City of
**Lake
Stevens**

ADA Transition Plan

Attachment A: City of Lake Stevens Standard Plan Markups

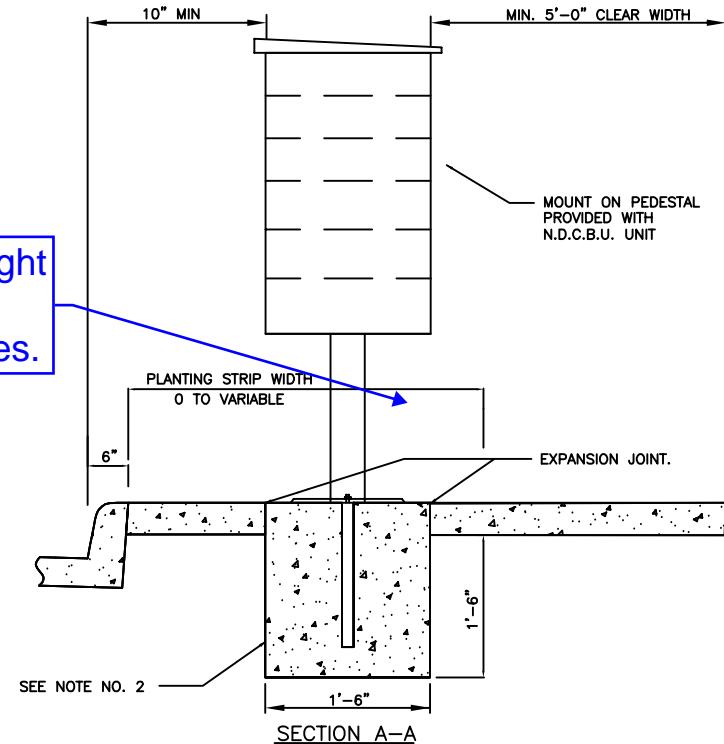
Add maximum height requirement to bottom of mailboxes.

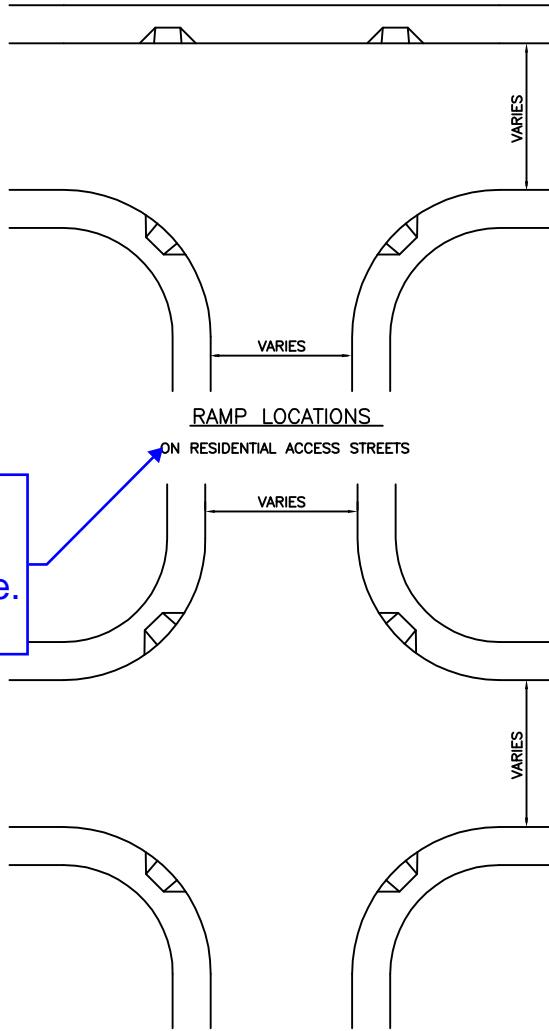
Dual ramps should be installed on all corners unless technically infeasible. update plan to reflect this.

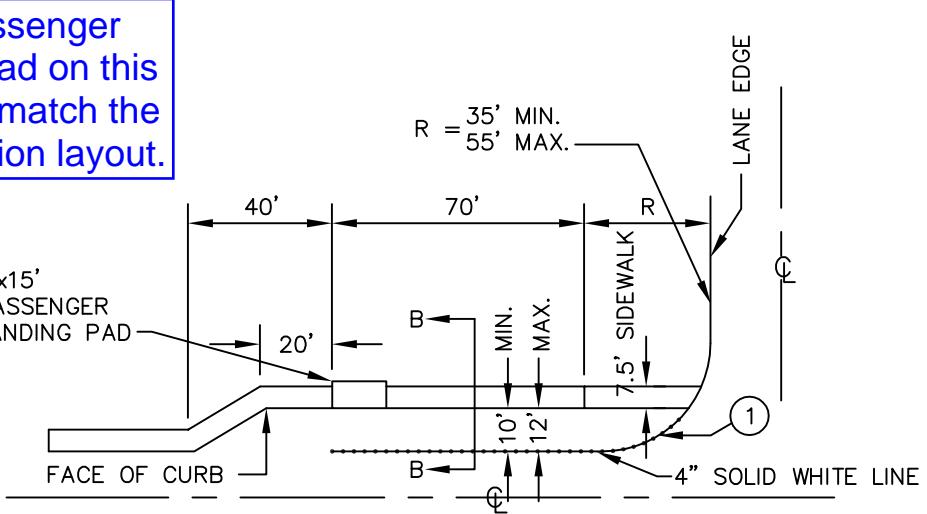
Label passenger landing pad on this layout to match the curb section layout.
